TO:	Long Grove PCZBA
FROM:	JAMES M. HOGUE, VILLAGE PLANNER
DATE:	June 28, 2016
RE:	Red Oaks PUD Modification\Redevelopment Proposal

Item: Consideration of a request to modify the previously approved Red Oaks special use permit ("SUP") and planned unit development ("PUD") and/or grant a new special use permit and/or text amendment to permit the demolition/reconstruction and use of certain existing buildings, to modify allowable uses within the PUD, to provide setback relief from the required 15' side and rear yard setback and 20' minimum building separation requirements, to provide relief from off-street parking regulations and/or additional relief necessary and/or appropriate under the zoning code submitted by Mr. Jesse Desoto.

ADDITION AND REMODELING
DANCE CENTER
LONG GROVE ROAD,
LONG GROVE, ILLINOIS

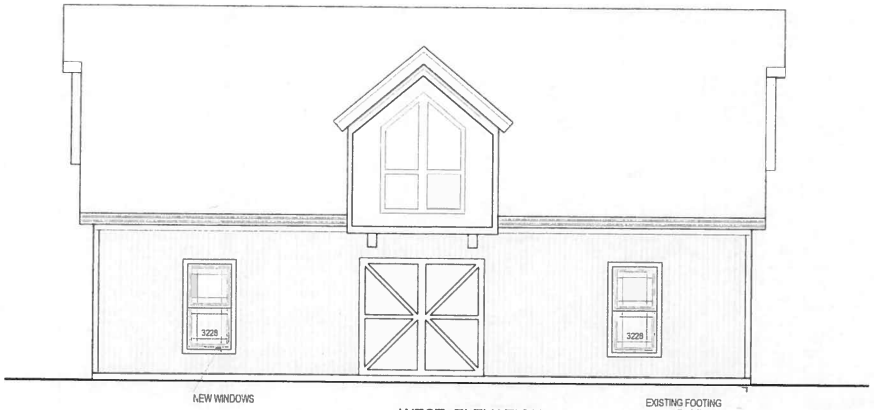
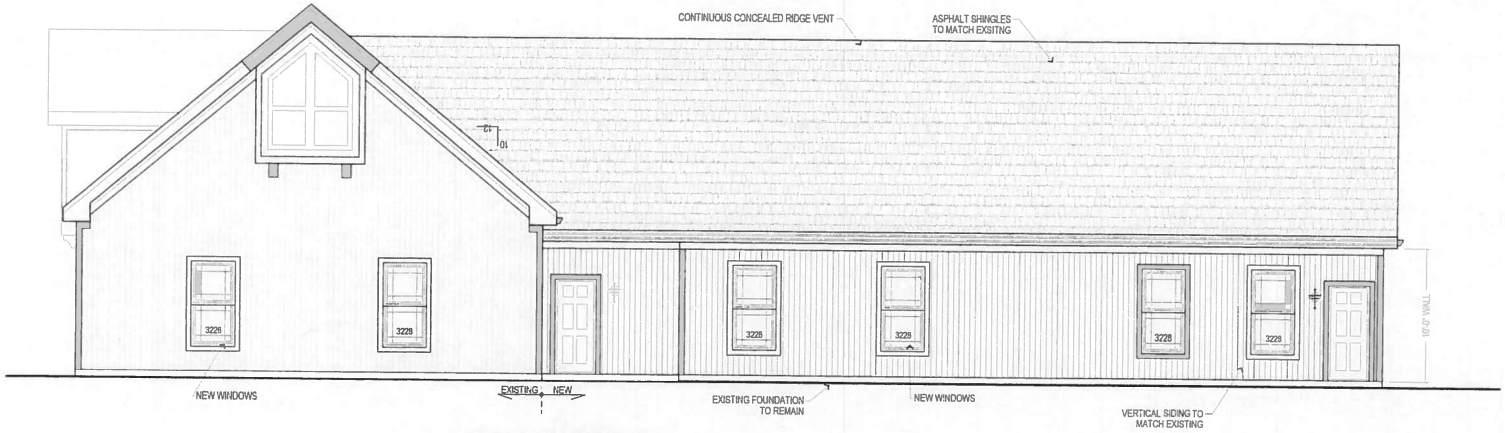
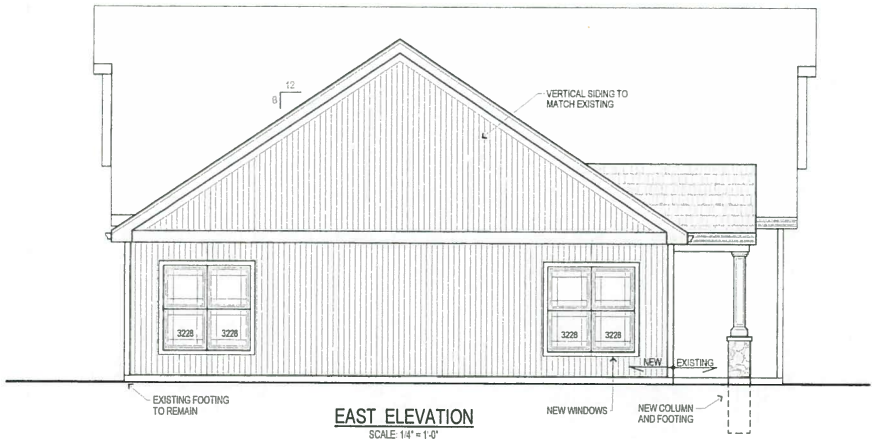
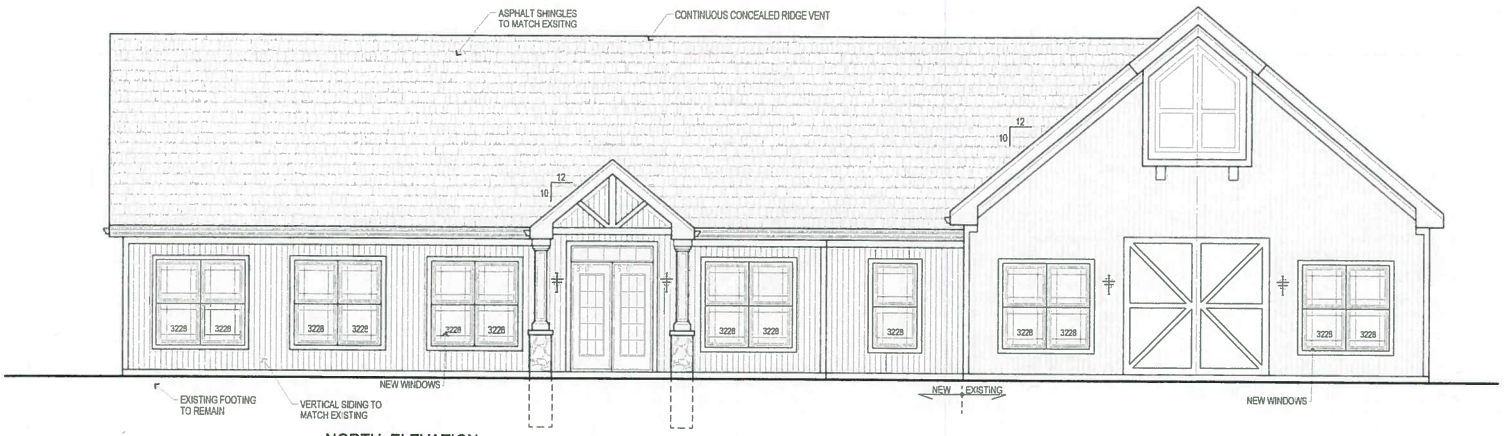
The replacement structure will complement the remaining barn structure and utilize siding & shingles to match the existing barn. The proposed reconstruction was reviewed and approved by the Architectural Commission on 6.20.16.

NEW SITE PLAN

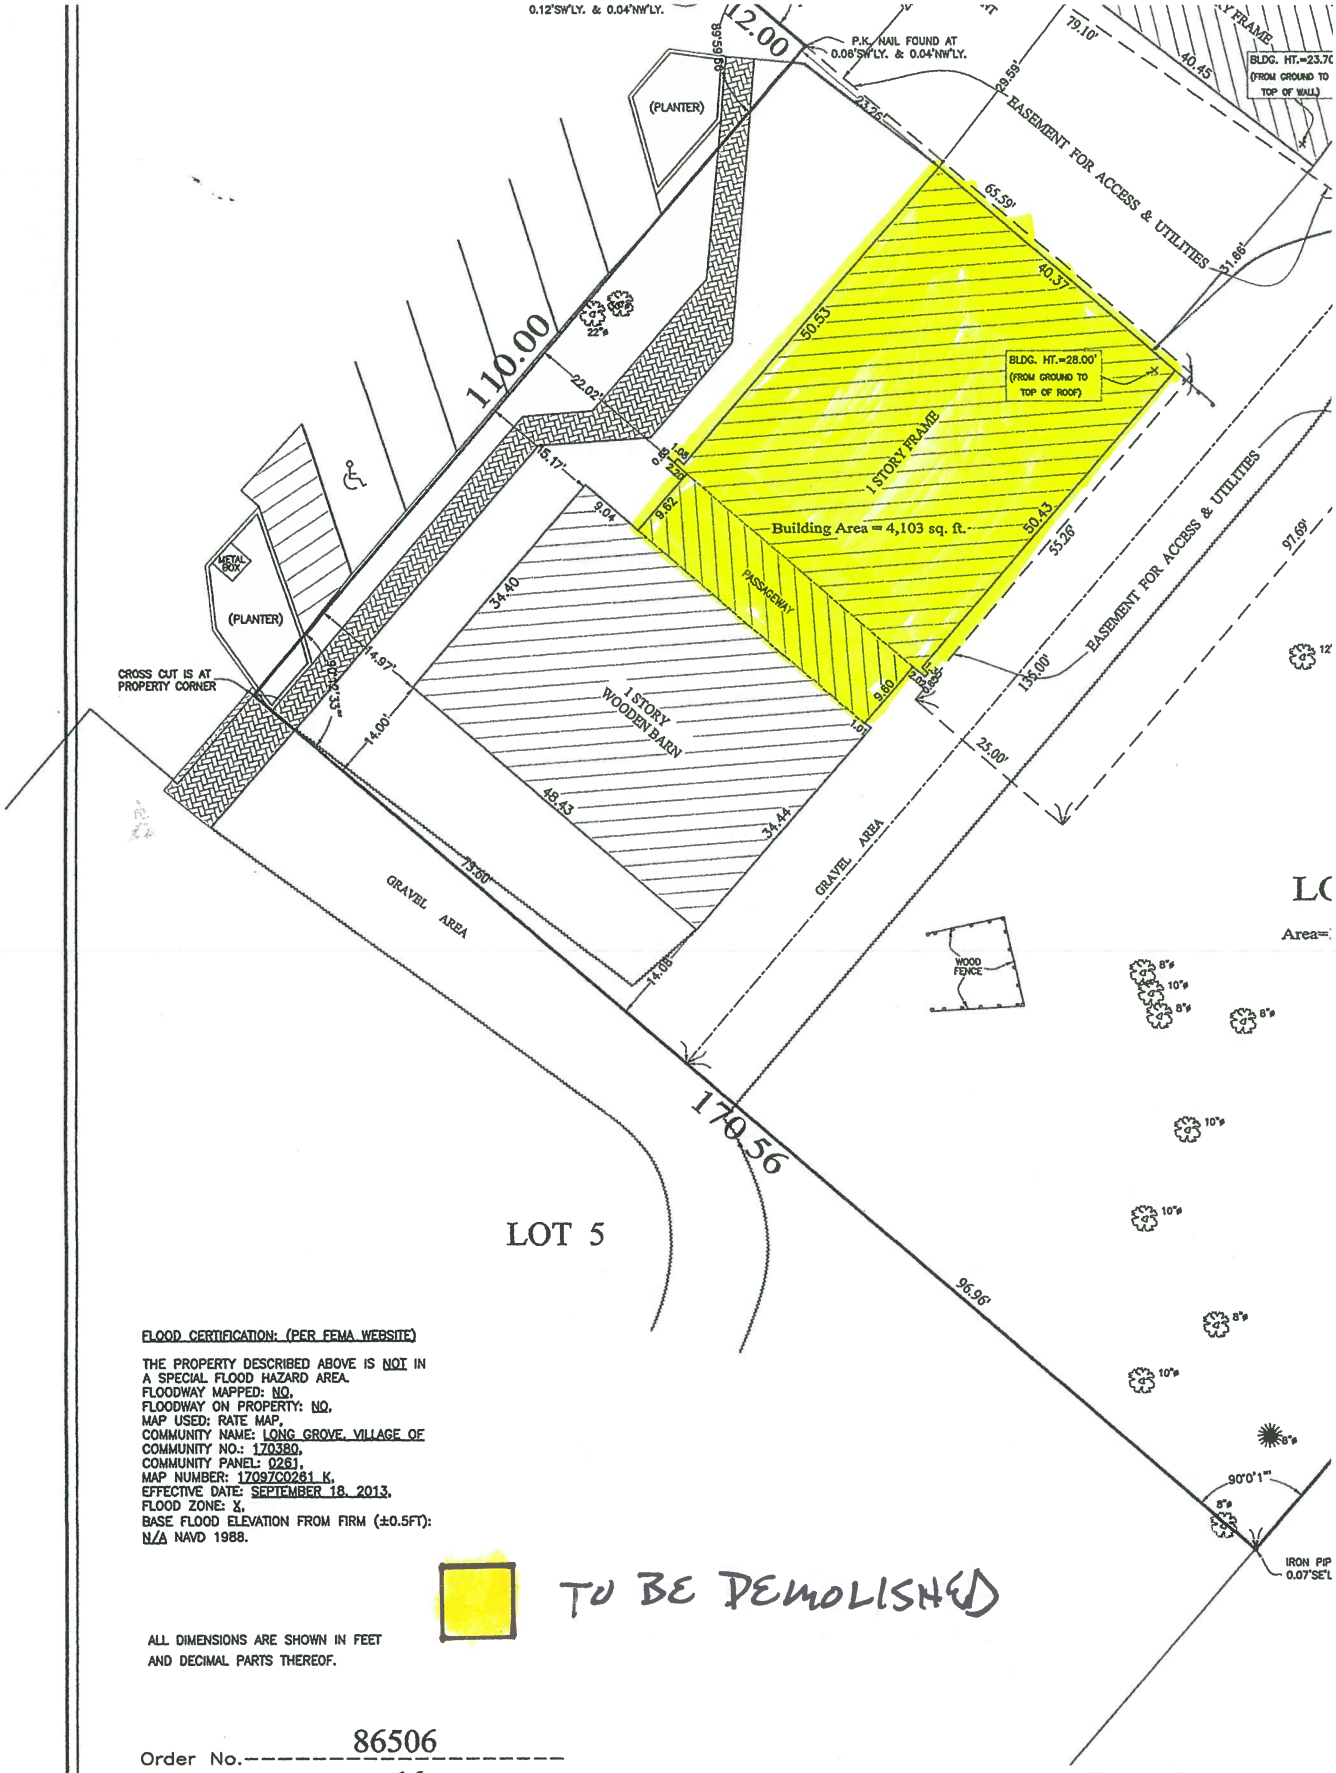
The petitioner is looking to demolish the north half (2000 sq. ft.) of the southernmost building (adjacent to the Studio) to accommodate a dance studio on Lot 1. The north half of this structure, which was approved as part of the Red Oaks PUD, was limited to and used for storage purposes. This portion of the structure is in a state of disrepair to the point where demolition is required. The petitioner proposes a replacement structure in the exact same footprint using the existing foundation & slab of the demolished building. The south half of the structure ("The Barn") will be incorporated into the dance studio as the dance floor space. Square footage will remain the same for the replacement structure as presently exists.

Setbacks with this structure are problematic with regard to the side lot line of 15'. Per the plat of survey the setback for this structure is only 10' with 15' being required. This structure is currently non-conforming and may remain as such. The demolition however will remove the non-conformity thus the structure must be rebuilt in a conforming manner or variation of the setback requirement sought. As the petitioner proposes to use the existing building slab & footprint no more relief than presently exists is require. Setback issues are identified below.

Side & rear yard setback variations are required and, in particular, for the replacement structure proposed by the petitioner. The required relief is 5 feet for the replacement structure and 6 feet on the existing structure. While an authorized variation, the amount of relief required exceeds the 20% maximum permissible in per the PUD regulations. As a side note, absent the PUD designation on the property there is no cap on the relief which can be requested. The PCZBA has typically looked for the minimum amount of relief necessary with regard to considering variations.
